UNITED STATES PATENT AND TRADEMARK OFFICE

APPLICATION NO.	FILING DATE	FIRST NAMED INVENTOR	ATTORNEY DOCKET NO.	CONFIRMATION NO.
10/625,174	07/22/2003	Hyun-Jin Chung	51876P351	8246
8791	7590	05/21/2004	EXAMINER	
BLAKELY SOKOLOFF TAYLOR & ZAFMAN 12400 WILSHIRE BOULEVARD, SEVENTH FLOOR LOS ANGELES, CA 90025			THOMAS, ERIC W	
			ART UNIT	PAPER NUMBER
			2831

Office Action Summary

DETAILED ACTION

FIG. 8

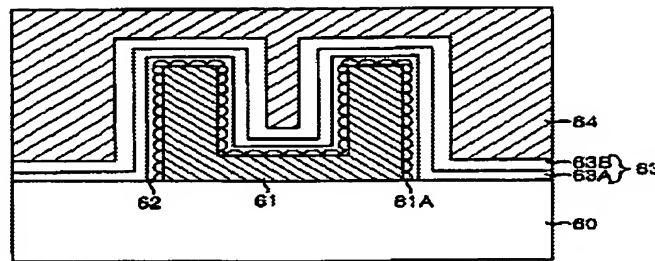
Lee et al. disclose in fig. 8, a capacitor comprising: an electrode (61); an oxygen diffusion layer (63A) containing aluminum (paragraph 86) on the bottom electrode; a dielectric layer (63B) on the oxygen diffusion barrier layer; and a top electrode (64) on the dielectric layer.

Regarding claim 2, Lee et al. disclose the capacitor further comprises an oxygen diffusion layer (62) containing nitrogen (paragraph 80) between the electrode and the oxygen diffusion layer containing aluminum.

Regarding claim 3, Lee et al. disclose the bottom electrode includes hemispherical grains in a surface thereof.

Regarding claim 4, Lee et al. disclose the oxygen diffusion barrier layer is an alumina layer (paragraph 81).

Regarding claim 5, Lee et al. disclose a method for fabricating a capacitor, comprising the steps of:

- a) forming a bottom electrode (61);
- b) forming an oxygen diffusion barrier layer (63A) containing aluminum on the bottom electrode;

- c) forming a dielectric layer (63B) on the oxygen diffusion barrier layer; and
- d) forming a top electrode (64).

Regarding claim 6, Lee et al. disclose step (a) includes the steps of:

A1) forming a hemi-spherical grains (61A) on a surface of the bottom electrode;
and

A2) forming an oxygen diffusion layer (62) containing nitrogen (paragraph 80) on the bottom electrode.

Regarding claim 7, Lee et al. disclose the oxygen diffusion barrier layer containing nitrogen is formed by using a rapid thermal process (paragraph 95).

Regarding claim 8, Lee et al. disclose the oxygen diffusion barrier is an alumina layer (see paragraph 86).
